Access Compliance Report

Public Rights-of-Way

(Curb Ramps)

Intersection ID: 17141	Main Street: PARK_RD	Cross Street: WYNDCROFTE_PL	Location: SW
ADA ID: 811CDB611CCC	Ramp Type: PerpDiag	Initial Pass/Fail: Pass	Overall Compliance: No
			Severity Score: 10.25

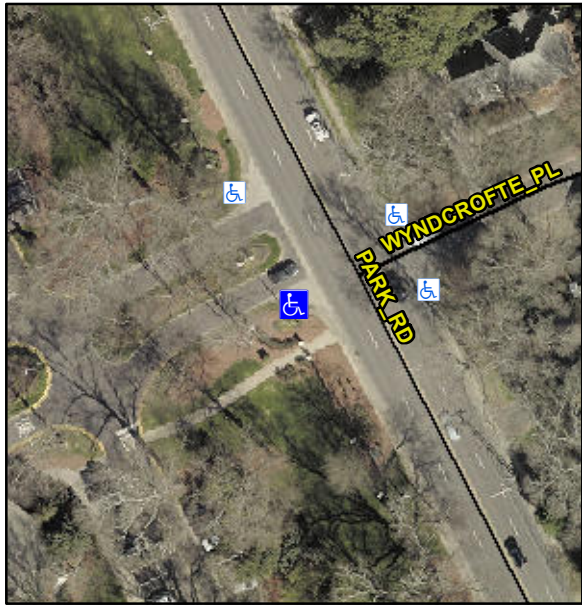
Codes/Mitigation Info/Possible Solution			Field Measurements/Component Compliance					
	Possible Solutions:		Compliance	Description	Data	Compliance	Description	Data
	Remove & Replace Curb Ramp With Two New Directional Ramps or Equivalent.		N/A	Ramp Length (in)	48.0	Yes	Ramp Slope (%)	6.8
			Yes	Ramp Width (in)	48.0	No	Ramp XSlope (%)	2.2
			N/A	Flare Type LT	Sloped	N/A	Flare Type RT	N/A
			N/A	Flare Slope LT (%)	8.3	N/A	Flare Slope RT (%)	6.6
			N/A	Flare Traversable LT?	Yes	N/A	Flare Traversable RT?	No
			No	Landing Length (in)	N/A	Yes	DWS Provided?	Yes
			No	Landing Width (in)	N/A	Yes	DWS Contrast?	Yes
			No	Landing Slope (%)	N/A	Yes	DWS Length (in)	24.0
			No	Landing X Slope (%)	N/A	Yes	DWS Full Width?	Yes
		N/A	Landing Curb? (Y/N)	No	No	DWS Offset (in)	6.0	
		N/A	Shared Landing?	N/A				
		Yes	Gutter Ponding?	No	Yes	Gutter Slope (%)	2.2	
		Yes	Gutter Lip Ht (in)	0.0	Yes	Gutter X Slope (%)	1.1	
		N/A	Painted X Walk1?	No	N/A	Painted X Walk2?	No

X Walk 1 Direction	To E		X Walk 2 Direction	To NE	
		N/A	X Walk 1 Width (in)	N/A	N/A	X Walk 2 Width (in)	N/A	
			X Walk 1 Slope (%)	2.7		X Walk 2 Slope (%)	4.3	
			X Walk 1 X Slope (%)	2.2		X Walk 2 X Slope (%)	3.5	
		N/A	Ramp inside XWalk1?	N/A	N/A	Ramp inside XWalk2?	N/A	
			Road Slope (%)	1.4	N/A	Clear Space?	Yes	
			Road X Slope (%)	4.7	N/A	Clear Space to XWalk (in)	N/A	
		Yes	Any Obstructions?	No	Yes	Storm Grate/Utility Hazard?	No	
			Obstruction Type			Storm Grate/Utility Type		
				N/A			N/A	
					Yes	Surface Condition? (G/P)	Good
